Local Planning Authority planning application reference: APP/24/00746

Site – 24 Treloar Road Hayling Island PO11 9SE

Proposal - Demolition of existing bungalow and erection of new two storey replacement dwelling including solar panels and flood defences.

Recommendation – Objection: there would be adverse visual impact to the setting of the adjoining Chichester Harbour AONB from increased bulk and excessive first floor glazing. This would be by reason of added bulk and mass across the width of the plot at first floor level. The proposals are therefore considered to be contrary to Policies CS12 (which also includes consideration of Policies 1-2 of the Chichester Harbour Management Plan 2019-2024), CS16.1 (a)/(c) & 7, DM9.2/3 and AL1 of the Borough Development Plan.

Outline of No. 24's roof shown with dotted red line above

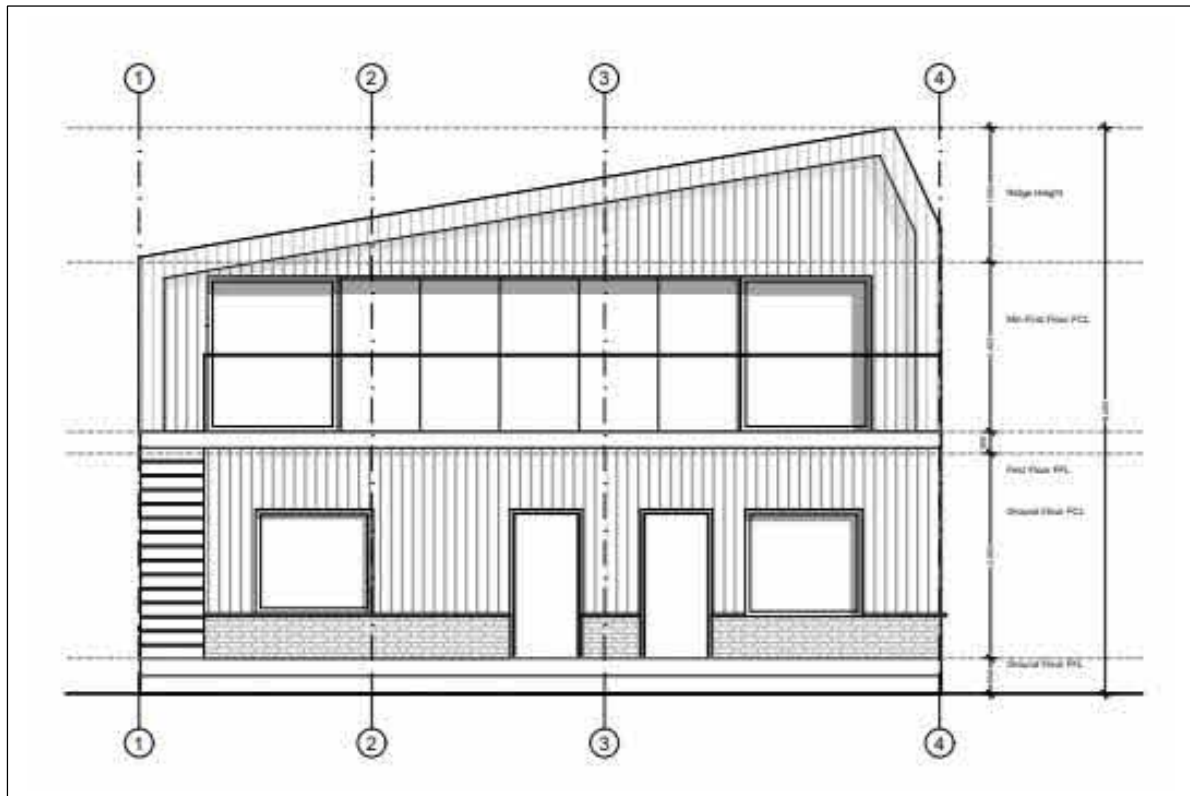
- 1.6 The existing dwelling has red brick facades, with a light-brown concrete tiled roof, save for flat felted roof areas and glazing to the corrugated roofing to the attached garage. The architecture of this modest bungalow is unremarkable. Ground levels on adjoining plots are approximately 30cm higher. Existing eaves height is 2.481 m and roof ridge 5.181 m high.

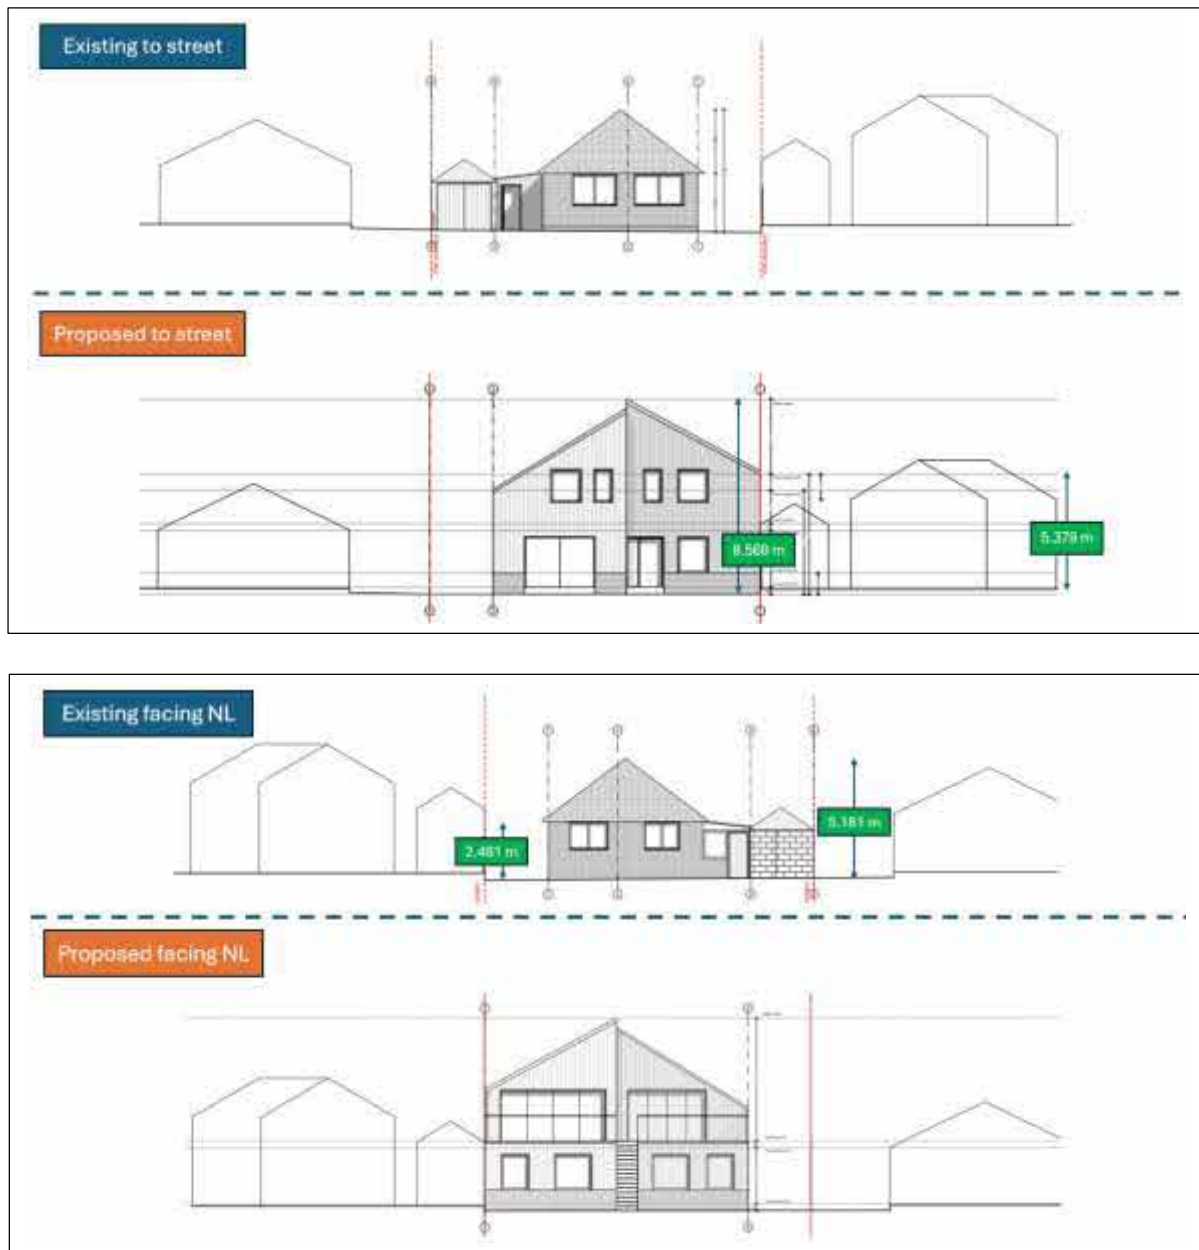
- 3.2 Large double, off-set balcony at first floor at rear looking out over Sandy Point Nature Reserve/SSSI. An external staircase would lead down from the balcony to the back garden. A considerable amount of full-length glazing would be fitted to this eastern elevation, the first floor not really tempered by any significant

recessing of openings. Solar PV would be fitted to the southern roof surface.

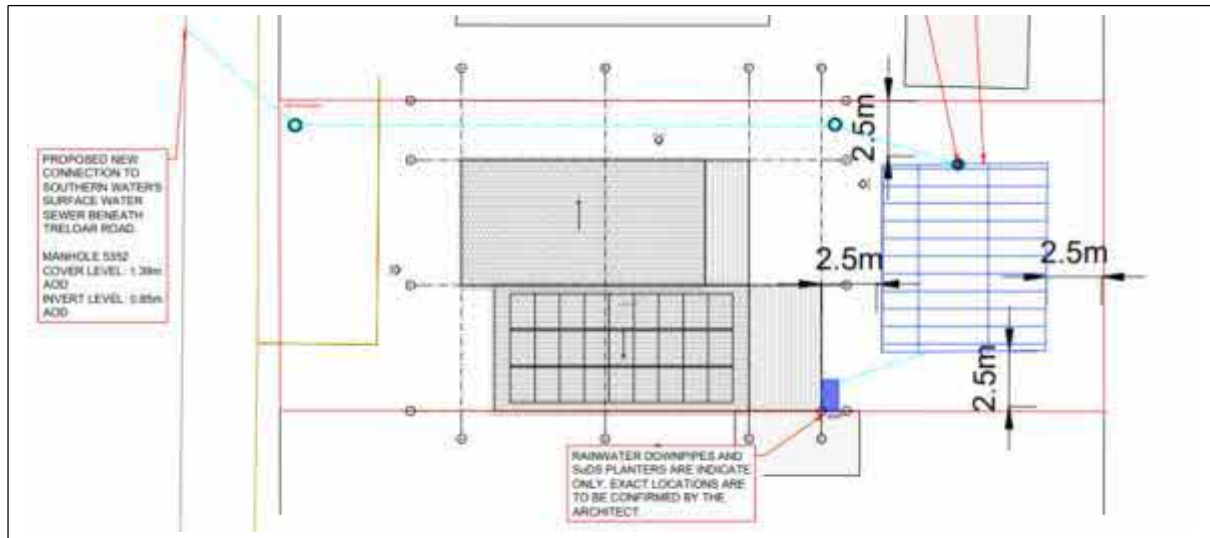
3.6 In terms of a surface water drainage strategy, the FRA concludes infiltration will likely not be feasible at the site. There is a separate surface water drain in Treloar Road. However, the site has a combined drain, which flows into the public sewer. As such separate systems will be created at the site and surface water is proposed to be drained to a new connection to the surface water main. To achieve a

betterment flow rate of 1 litre/second, it is proposed that the surface water runoff from the development is managed via a geocellular storage tank and maintained – (paragraph 6.27 of the FRA) SuDS planter in the back garden (see solid blue shape in diagram below). The available cellular storage has been modelled at available storage 9.384m³.

3.8 The proposed floor and roof plans are shown below.

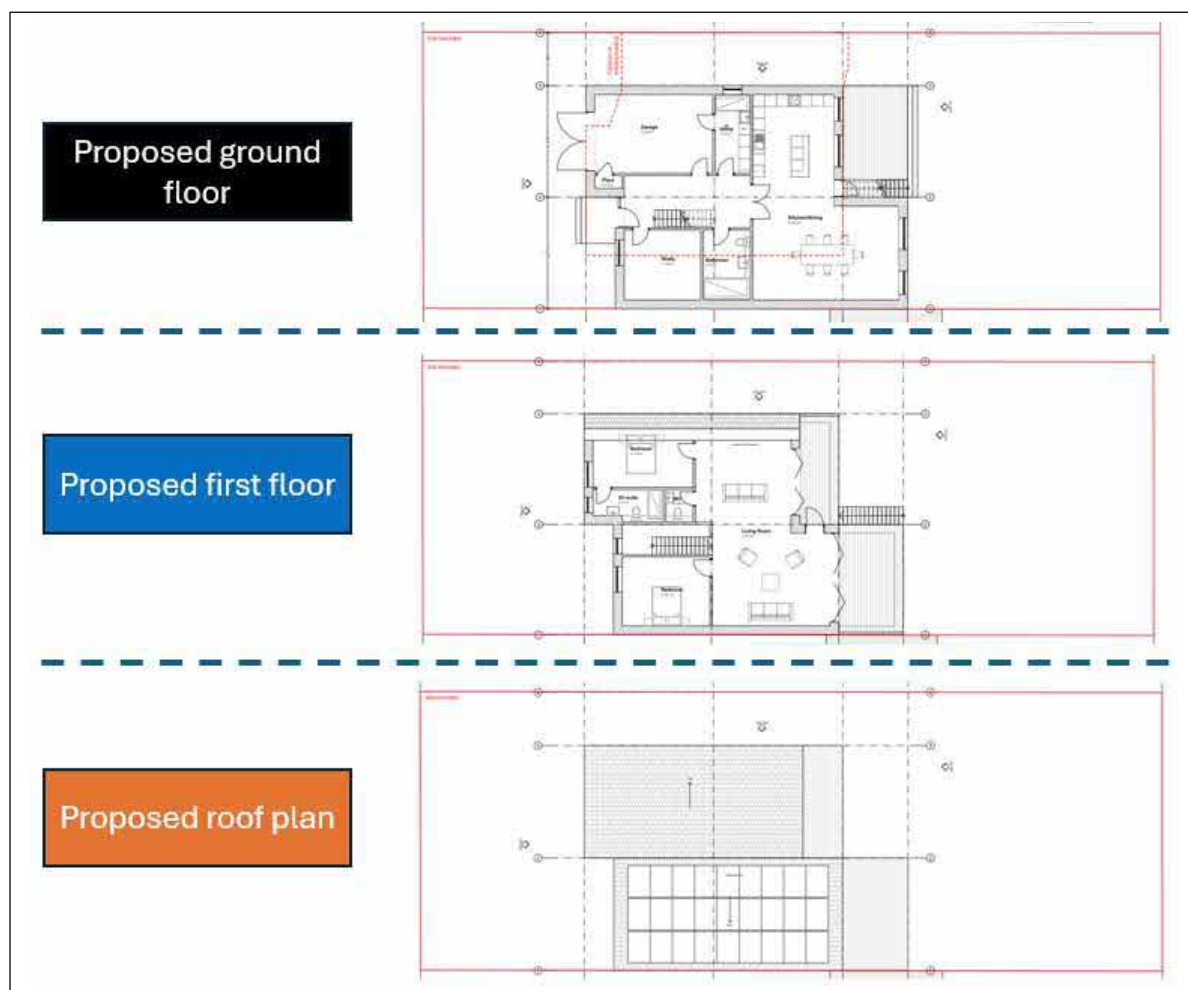
4.3.2 However, criticism is made above of the impact of increased massing, especially at first floor, across much of the width of the plot. A large amount of glazing is proposed and that at first floor considered to come too close to the roof plane, with little vertical alignment with that below it.
